Access Compliance Report

Public Rights-of-Way

(Curb Ramps)

Intersection ID: 8636	Main Street: HATERAS_AV	Cross Street: KENNESAW_DR	Location: NW
ADA ID: 2941123275B6	Ramp Type: BlendTrans2	Initial Pass/Fail: Fail	Overall Compliance: No
			Severity Score: 21.25

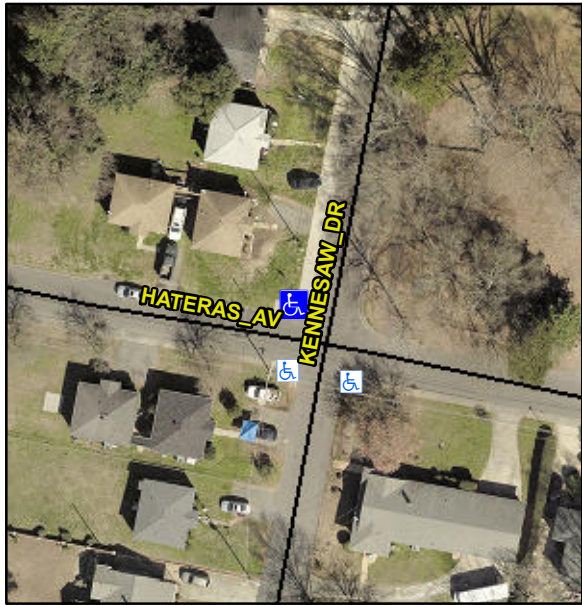
Not Found, R304.5.1, R304.5.3

Remove & Replace Curb Ramp With Two New Directional Ramps or Equivalent.
